Application Ref. 2014/3640/P and 2014/3806/L
Objection: Eye Catcher Proposed Development, Brunswick Centre

Please register this letter and its contents as an objection to the proposed planning and listed building applications for the 'Eye-catcher' development, planning reference as stated above.

Above: Misleading current application (2014/3640/P) ground floor plan Drawing 2937a_D-110 P3 showing old Renoir footprint.

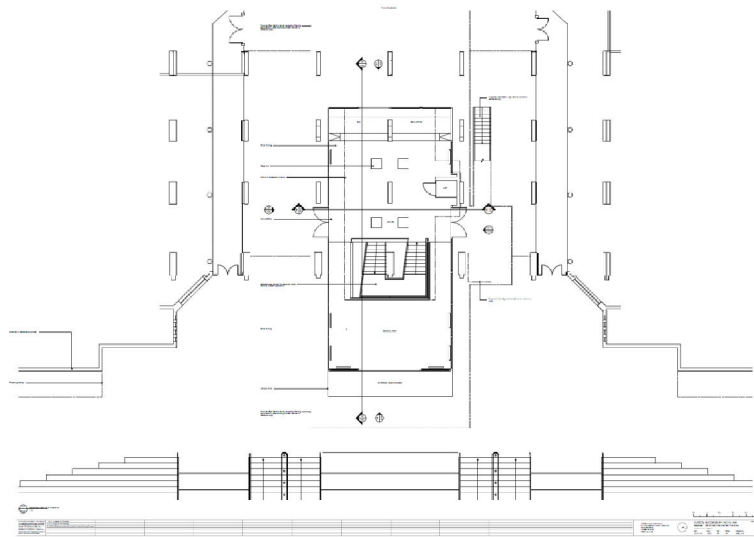
- a. The BTRA pointed out in its letters of 21.07.2014 and 20.08.2014 the BTRA noted that the Ground Floor Plan submitted by the applicant should be revised as it did not show the consented Renoir foyer expansion and was therefore misleading as it showed the opening into the Brunswick as wider than it will be if current application be permitted to go ahead.

- b. The only ground floor plan in the application documentation Drawing **2937a_D-110 P3 'Level A Plan'** shows the old Renoir ground plan, not the ground floor plan for the consented Toh Shimazaki scheme to extend the cinema foyer (application reference 2014/0481/P) that is currently under construction. Please refer to **2937a_D-110 P3 'Level A Plan'** drawing from the current application and drawing **386-014 Rev A** from the consented Toh Shimazaki scheme to expand the cinema foyer. (Like the BTRA I point out that this is despite the fact that the decision notice was issued for the Renoir refurbishment on 16 June 2014 (Application reference 2014/0481/P) almost a month before the proposed Eye-catcher was registered on 04 July 2014.)

Above: Eastern Elevation of the Brunswick Portico from Hunter Street showing the reduction of the opening over time.

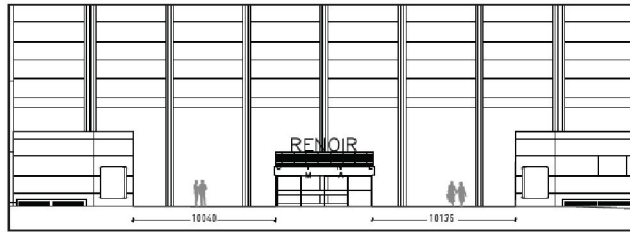
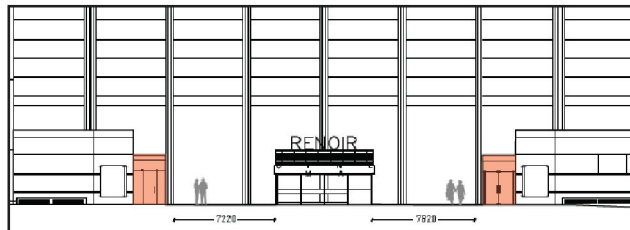
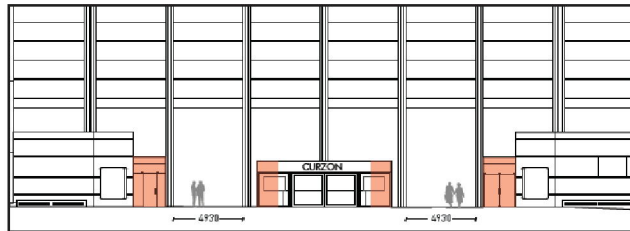
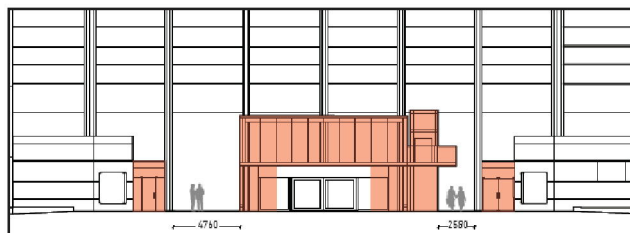
- c. The consented Renoir application currently under construction will, when built, reduce the opening width of the pedestrian passageway by approximately 4 meters, the design for the proposed 'Eye-catcher' application would reduce the opening by a further approximately 2.5 meters by introduction of a lift, service riser and stair – **a joint reduction of more than half the current opening into the centre**. The reduced opening will restrict pedestrian movement and views through the eastern entrance to the Brunswick Centre. It will deteriorate the amenity of the public space, reduce natural light to the adjacent units and compromise the safe and equal access to the building by restricting pedestrian movement.

- d. The inclusion of the old Renoir ground plan in the ground plan for the new proposal was a deliberate attempt by the applicant to conceal the extent of the reduction of the passageway – a reduction of more than half the current opening into the centre.

Above: BTRA overlay of the massing models submitted in the Design and Access Statement on the submitted plans

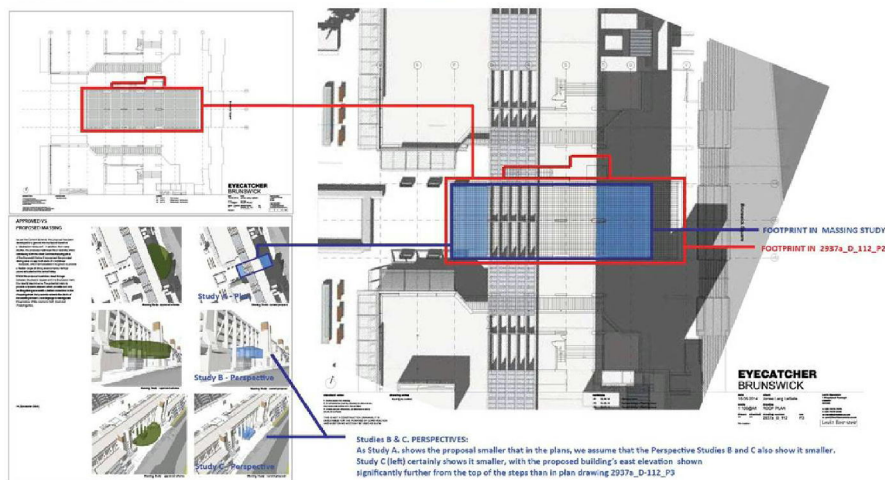
- **Design and Access Statement, pages 14 and 15** show the massing of the proposed scheme illustrated in blue (see below and attached). The massing incorrectly shows the volume significantly smaller than the plans and sections and do not show the proposed staircase, lift core or service risers (Drawing 2937a_D_112 P3, 2937a_D_11 P3, 2937a_D-200 P3, 2937a_D_201 P3, 2937a_D_203 P3). These illustrations are deception and misleading as that they do not show the reduced passageway into the centre. These were not corrected by the applicant following the BTRA's letter of 21.07.2014.

SIZE OF PROPOSAL SHOWN SIGNIFICANTLY SMALLER IN MASSING STUDIES THAN IN PLAN

The drawing below show the Massing Study A overlaid on the Design and Access Roof Plan. The overlay shows it is shown significantly smaller in the massing studies and does not show the stair, lift or elevated Level 1 external platform.

Above: BTRA illustration showing distances from the restaurant's openable windows, elevated external raised platform for deliveries, mechanical services and distance from people from entering and exiting the restaurant via the stairs and front door.

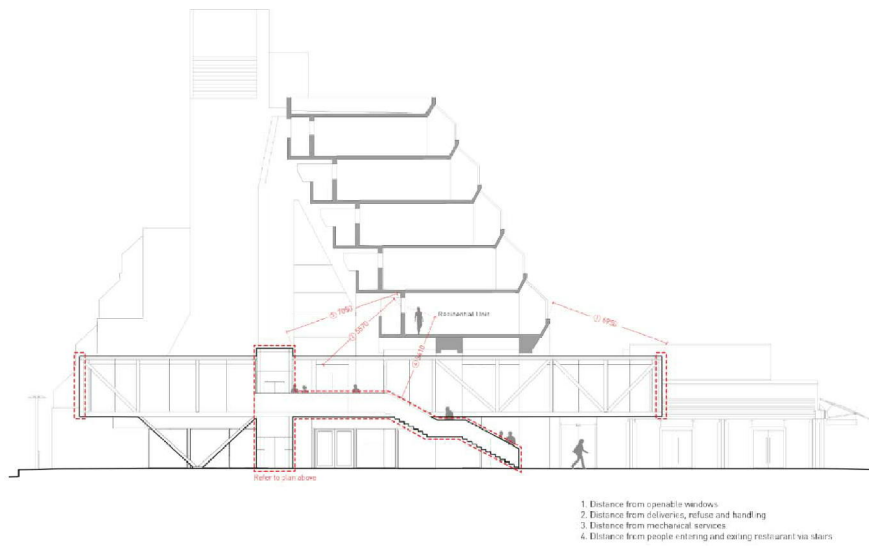
- **The noise generated by people using the restaurant would only need to travel metres from the windows of the proposed design to the opening windows of the flats above.** Access to the restaurant, via an open platform would lead customers visiting the premises to generate noise and activity which would be perceived by the locals and due to its raised position any noise generated would travel further and be more of a disturbance than the current levels of noise generated at ground level.

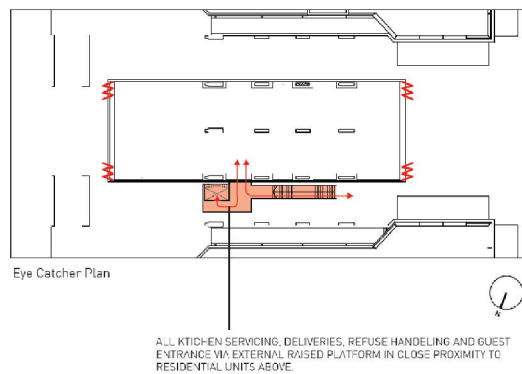
- d. The proposed access for deliveries to the unit and removal of refuse appears to be solely via a public use glass elevator that passes to basement level. **The elevator used for deliveries opens out onto an elevated external platform at level 2, meters from the opening windows of residential properties at level 3.** From here it is taken (trolleyed?) through the main and only entrance doors into the restaurant.

- The noise that would be generated to service a premise of this type at the level of the external platform would be considerable and the hours of servicing unfeasible within the local context.

- The proposed access strategy for the design would create significant noise pollution that would be harmful to the amenity of the neighbouring residential and commercial units.
